Sign Variance Appeal

55 Bloor St W
August 20, 2020

Proposed Signage Master Plan Description

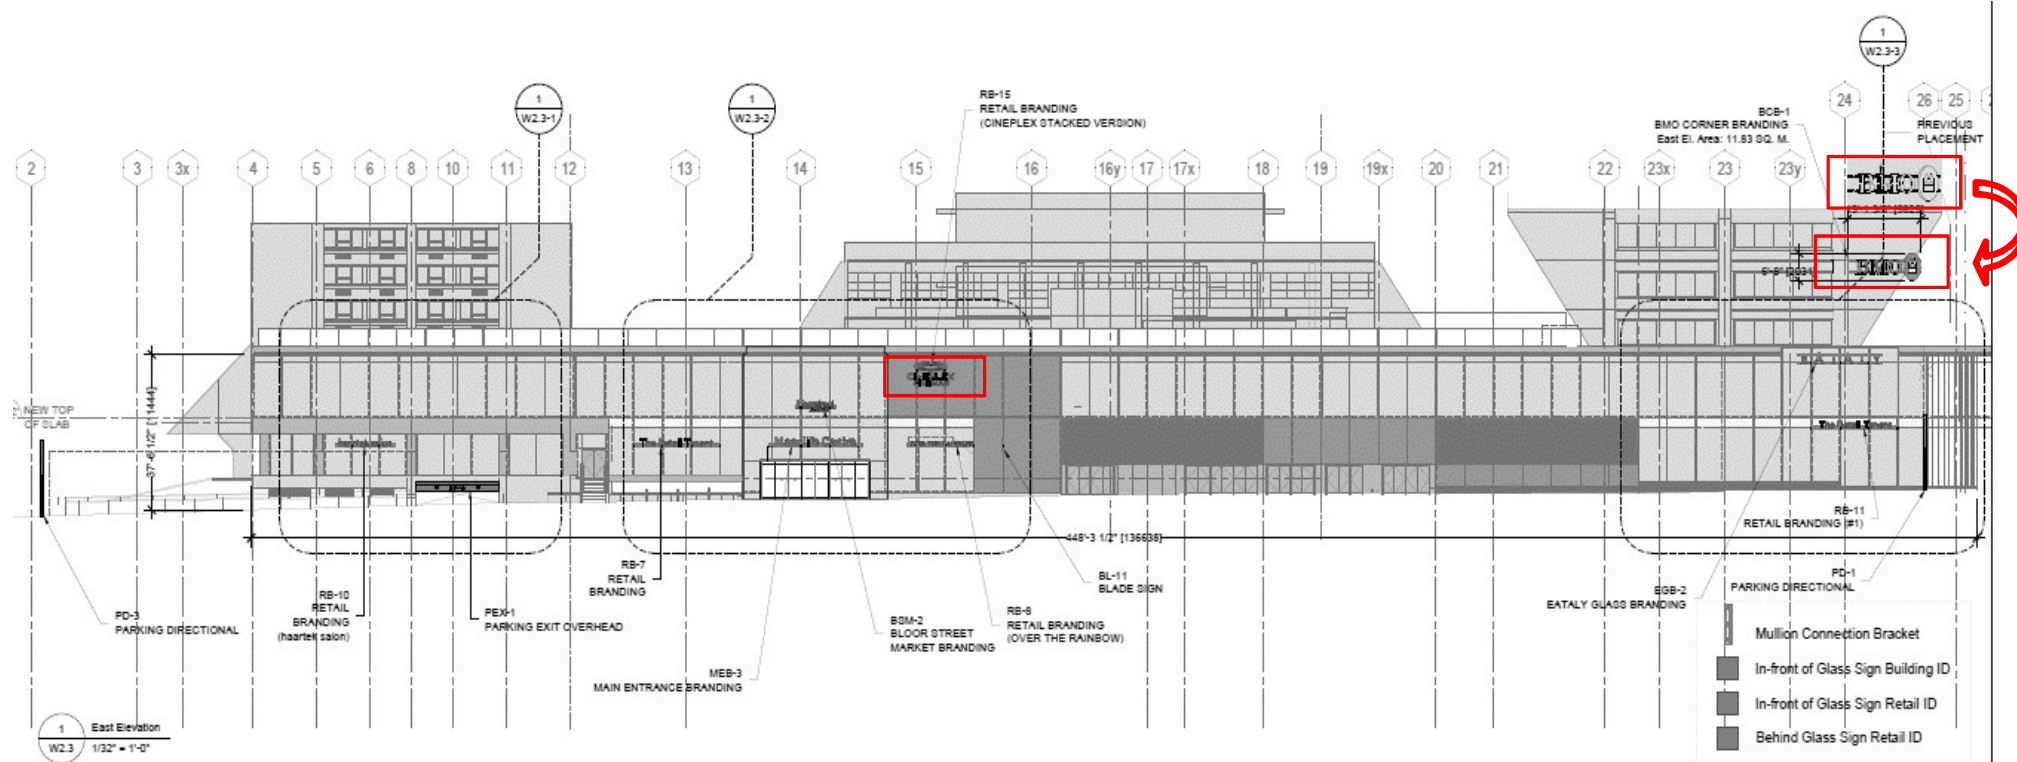
One projecting sign, exceeds the maximum permitted area and projection from wall face. This sign has more than two faces and is not perpendicular to the wall

Two overhanging structure signs are located above the second storey. The signs will be located between the fourth and fifth storey

Changes from 2018 Signage Master Plan – East Elevation

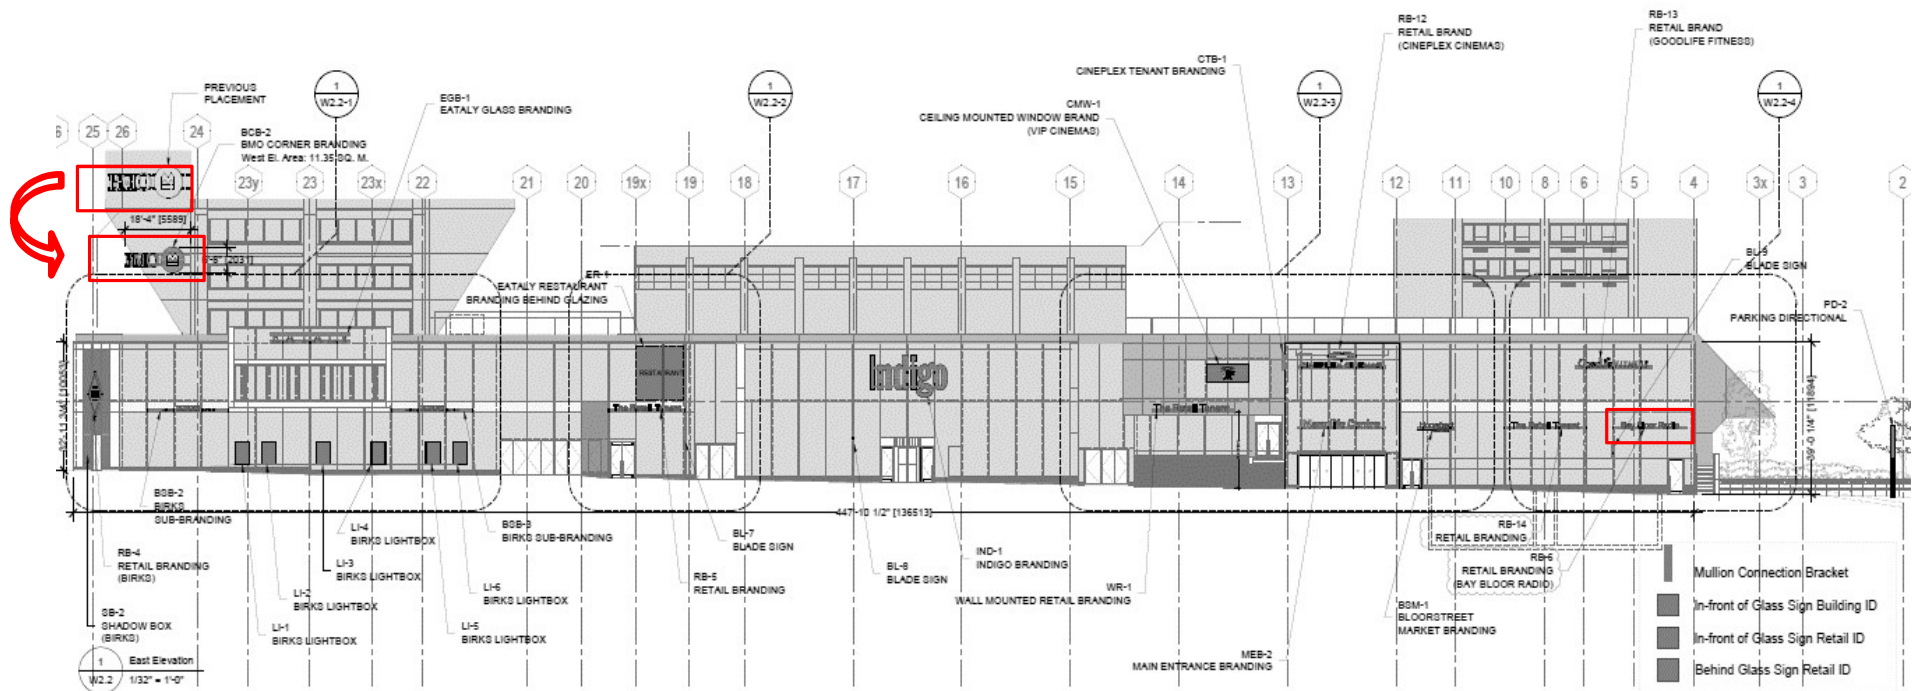
- On November 28, 2019, the Applicant submitted the 2019-Signage Master Plan.
- The main changes from 2018-Signage Master Plan are:
 - one wall sign has been added to the second storey at the east elevation,
 - one wall sign has been added to the first storey on the west,
 - two overhanging structure signs proposed to advertise BMO (removed from the Approved 2018-Signage Master Plan) have been modified in size and height.
- On June 25, 2020, the CBO refused the variances requested for the 2019-Signage Master Plan.
- On July 20, 2020, the CBO's decision was appealed.
